Planning Commission Issues Report

Subject: Change of Zoning Issues Report
Meeting Date: November 24, 2014
From: Jonathan Raiche, Senior Planner
Location: North of Wild Horse Creek Road, west of its intersection of Long Road and east of its intersection with Savonne Court
Petition: **P.Z. 09-2014 Bur Oaks (17751 Wild Horse Creek Road)**

The following responses are in reference to the comment letter from your office dated November 4, 2014.

DRAWN BY: J.M.B. CHECKED BY: G.M.S.
 DATE: 08/12/2014 JOB NO: 213-5241
 M.S.D. P. # P-300000000 BASE MAP # 15-F
 S.L.C. PART # XXXX HMT SLP. # XXX-XXX-XX
 REVISION # MO-XXXXXXX
 SHEET TITLE: LAYOUT EXHIBIT
 SHEET NO.: 1 of 1

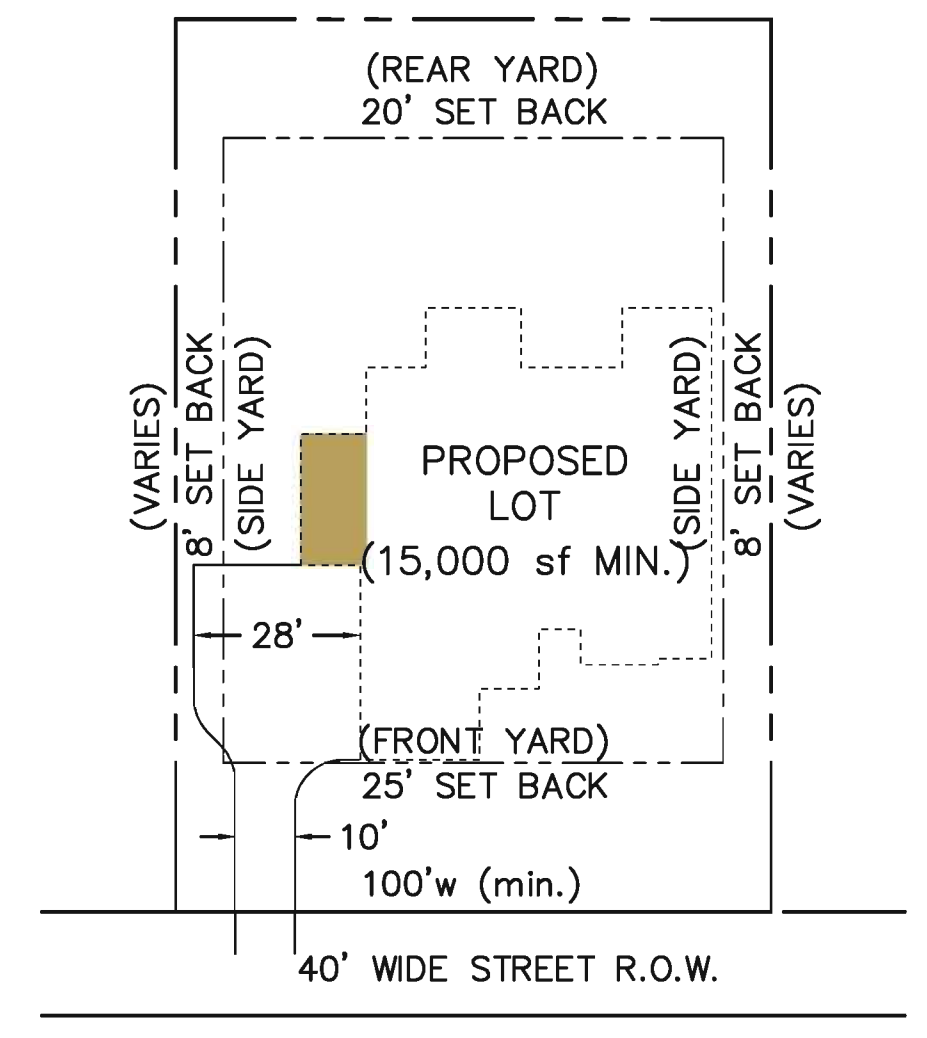
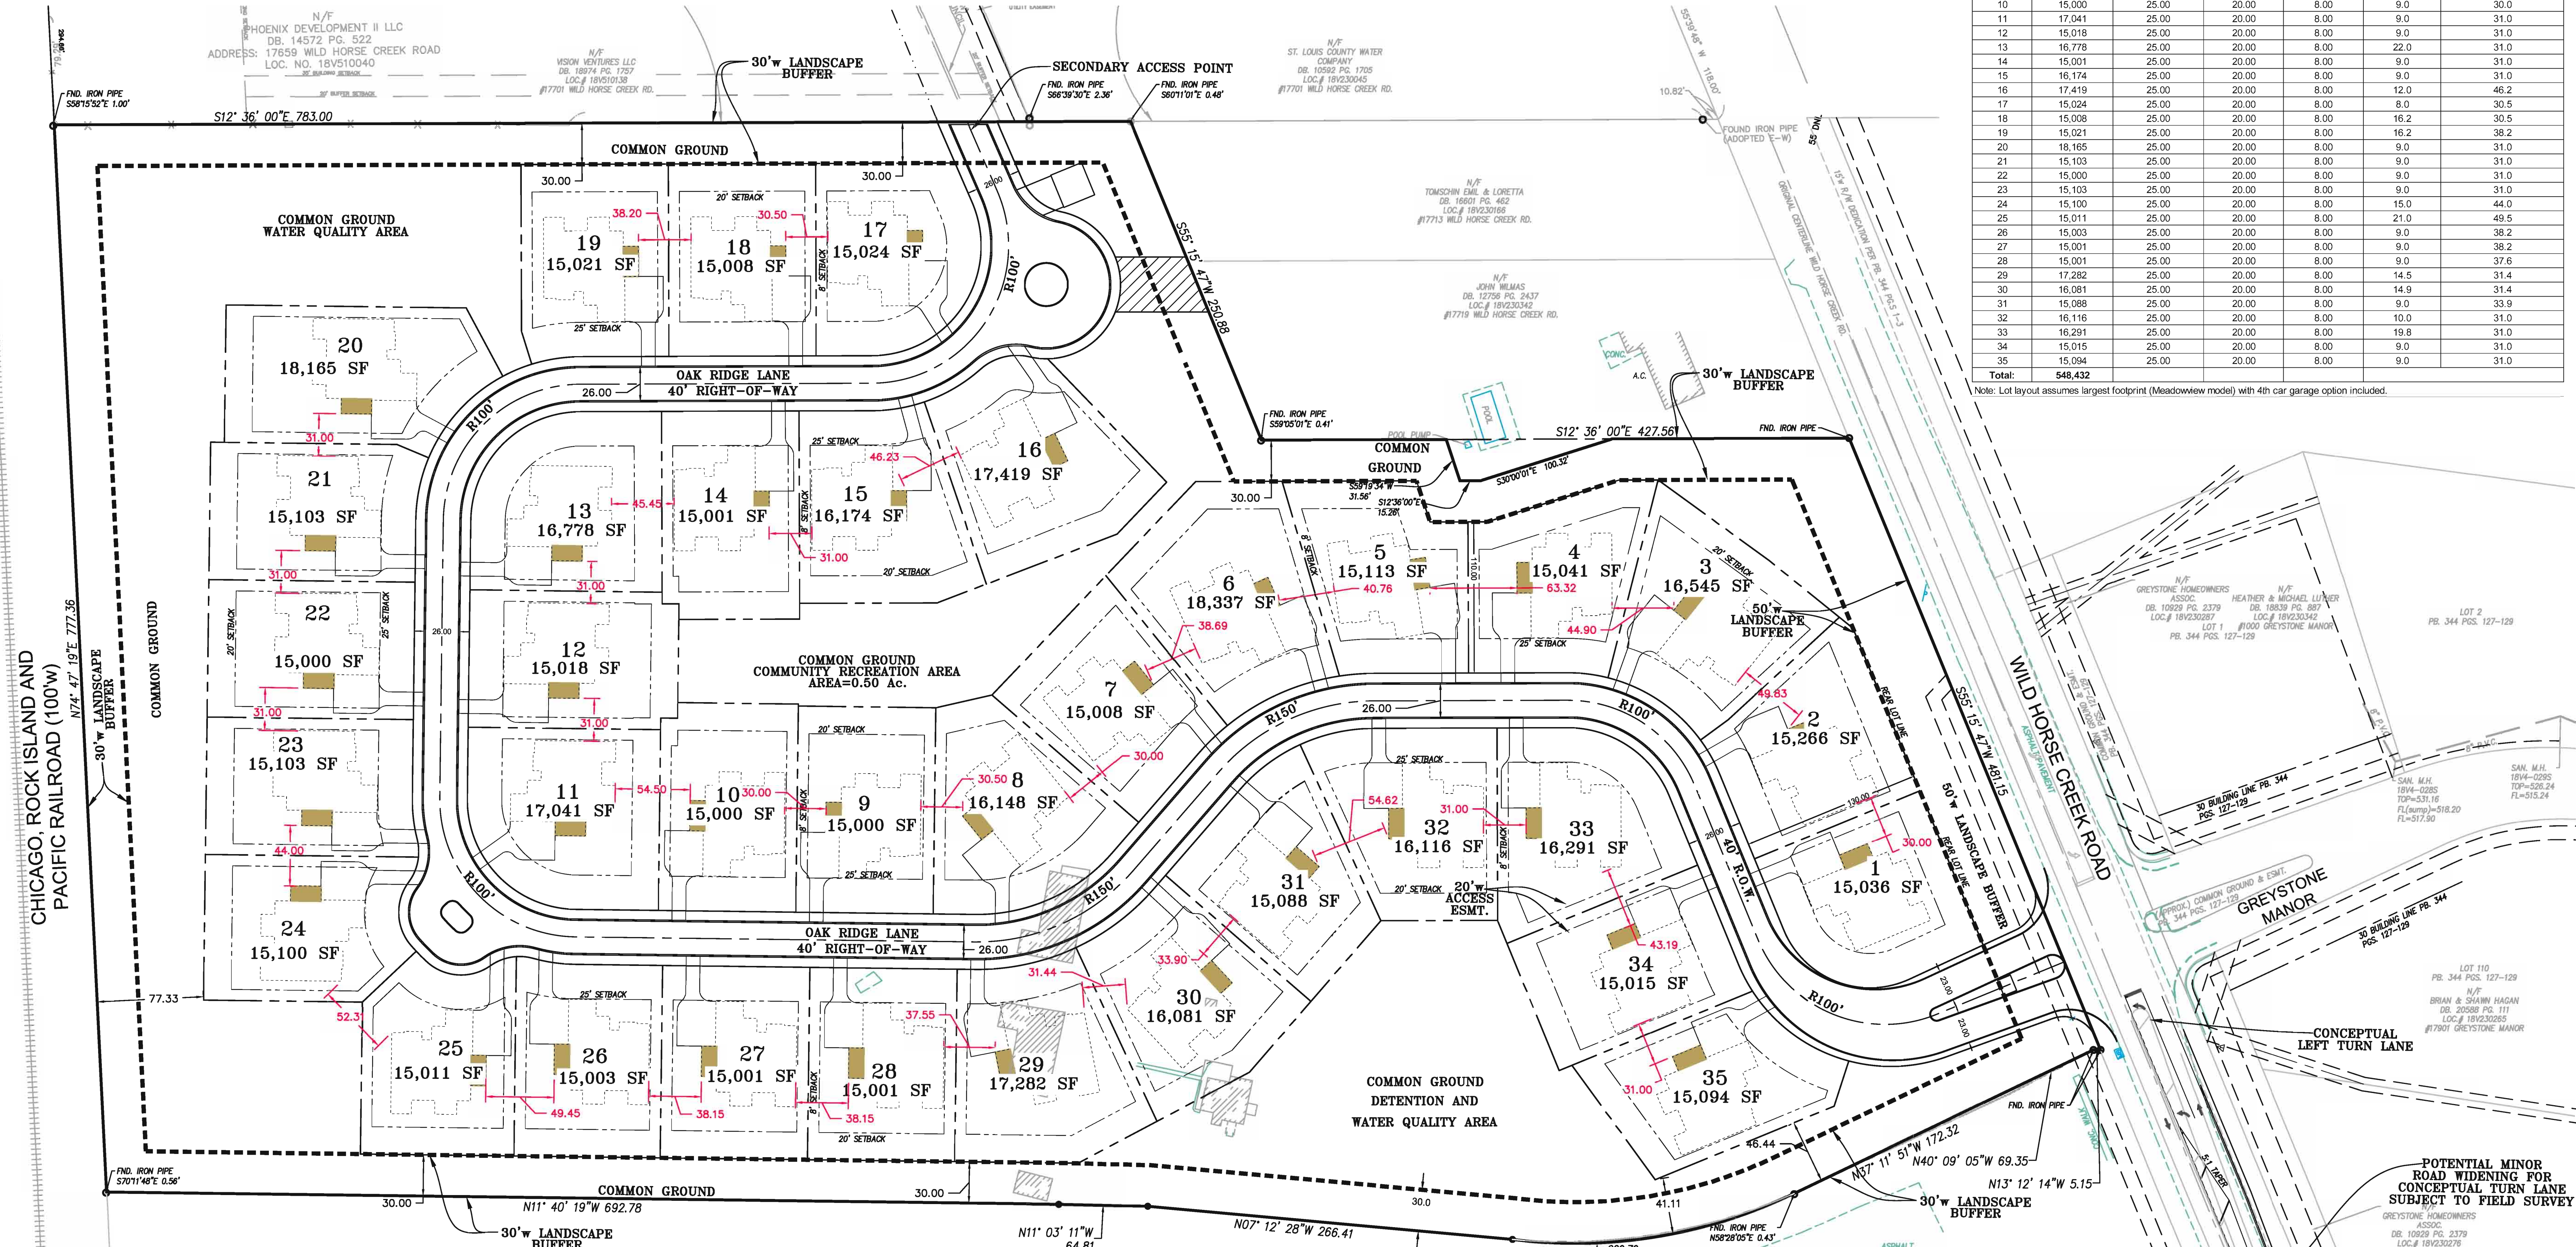
1. The applicant is requesting a modification to allow for a 16’ setback between structures. Planning Commission would like further information related to the number and location of lots that will actually require this reduced setback.

Response: The Preliminary Plan provides for a minimum of thirty feet (30’) between homes as outlined in the E-1/2 Acre zoning district. The Preliminary Plan utilizes the largest home footprint with a fourth-car optional garage shown to display the widest possible structure on every lot; however it is highly unlikely that all homes will be the largest footprint with a fourth-car option added so the distance between homes will be greater than minimum dimensions shown in many cases. The side yard setback requirement is consistent with this “high-end” home which provides a side entry garage. The side entry garage requires a home to be placed off-center on the lot, thus requiring the eight ft. (8’) side yard setback. As demonstrated, the variance of side yard setback will not cause the 30 ft. side yard home separation to be compromised as demonstrated on the attached C1.1 Typical Layout drawing.

PRELIMINARY PLAN

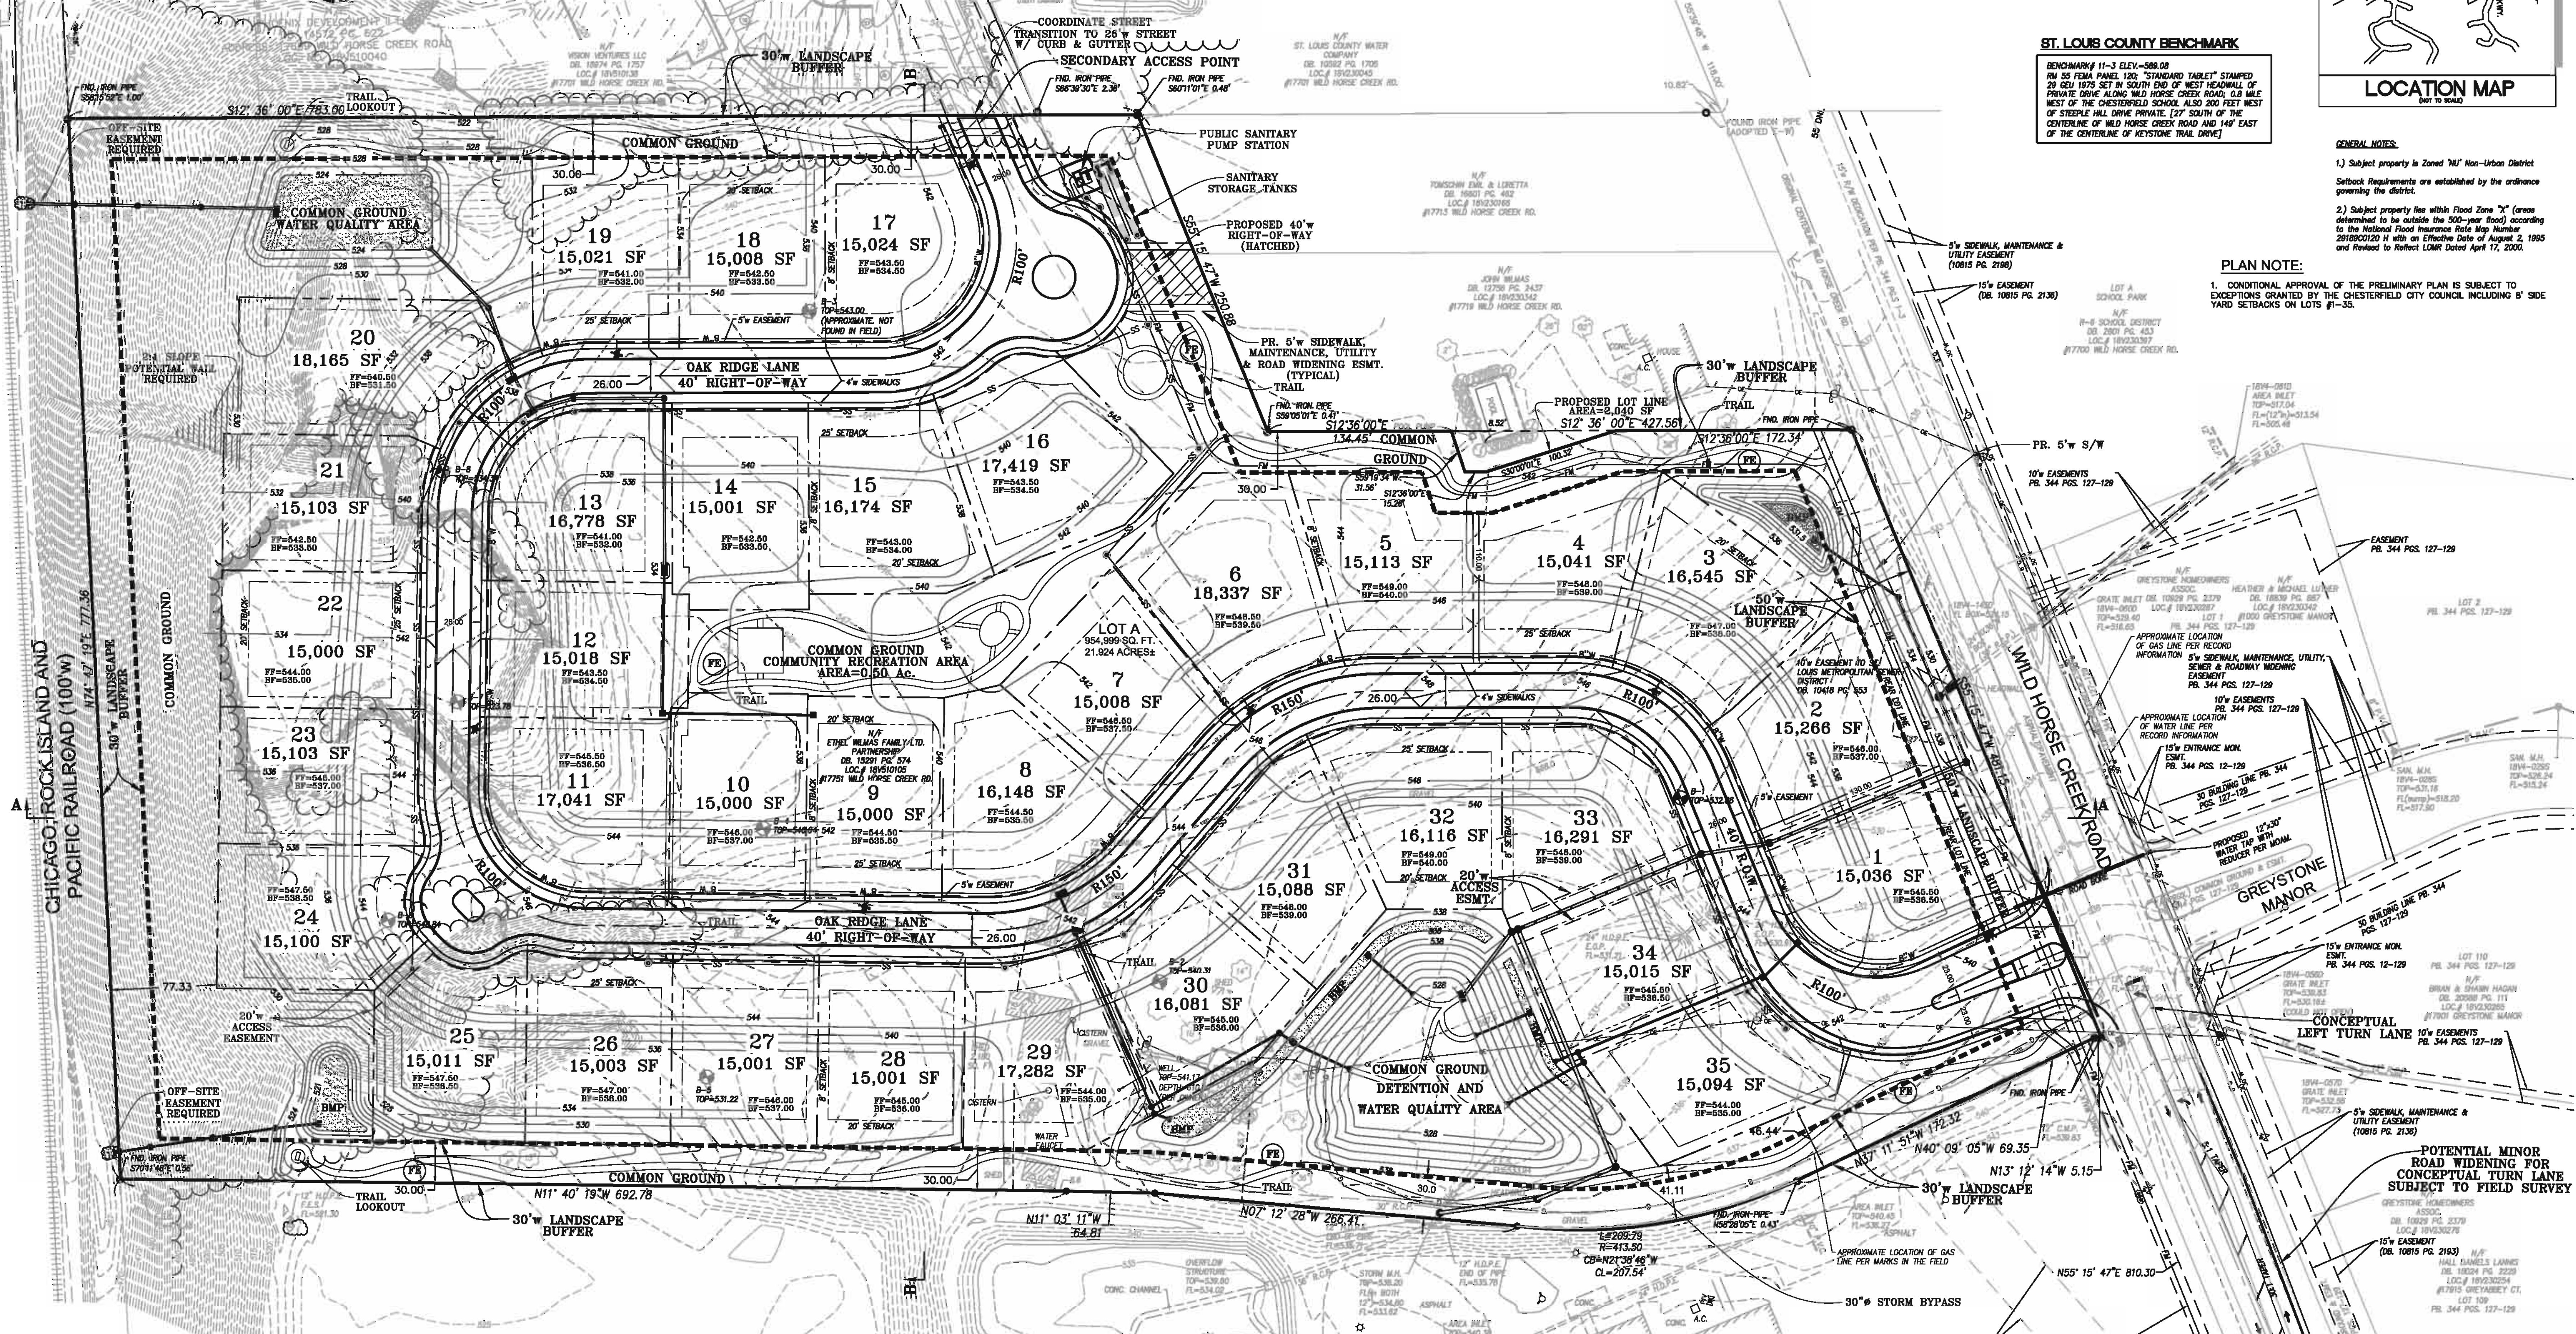
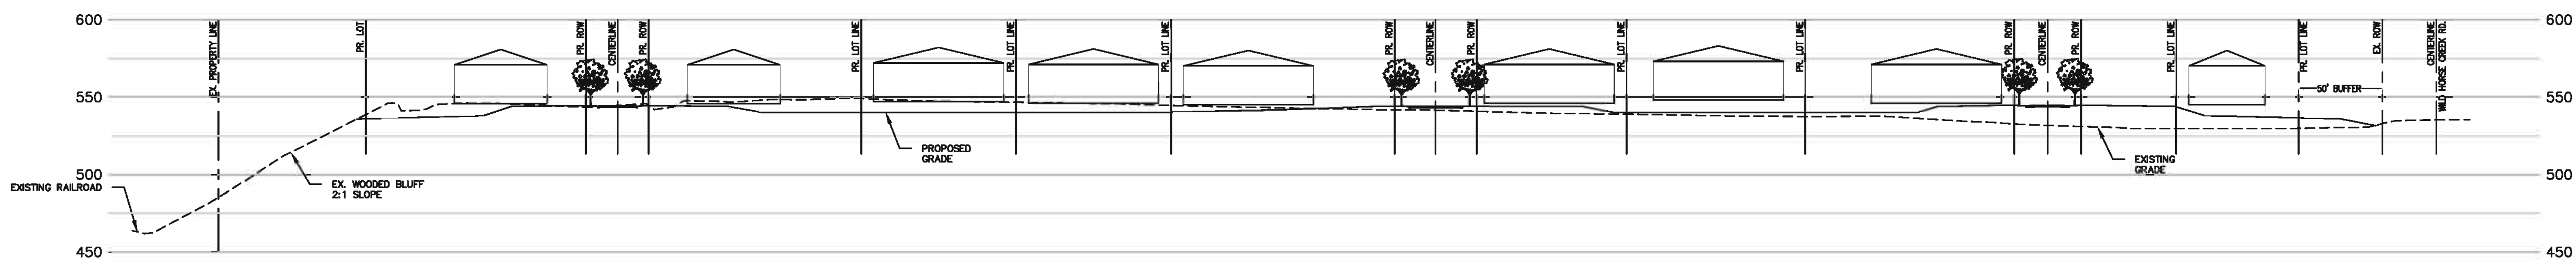
9. Evaluate access to the proposed BMP in the northwest corner of the site and provide a 20' wide (minimum) stormwater control easement, as necessary.

10. Because the design of the left turn lane on Wild Horse Creek Road has not been finalized, remove the dimension label shown for the length of the left turn lane. Also add a note to the plan indicating that the left turn lane is conceptual and the design will be finalized during the site plan process.

11. The current street width provided does not allow for on-street parking. A note should be added to the Preliminary Plan and all subsequent plans to indicate this restriction.

Response: Access easement added to plans. See revised sheet C1.0.

Response: Dimension removed from plans. See general note #14 on revised sheet C1.0.

Response: See noted #6 on sheet C1.0.
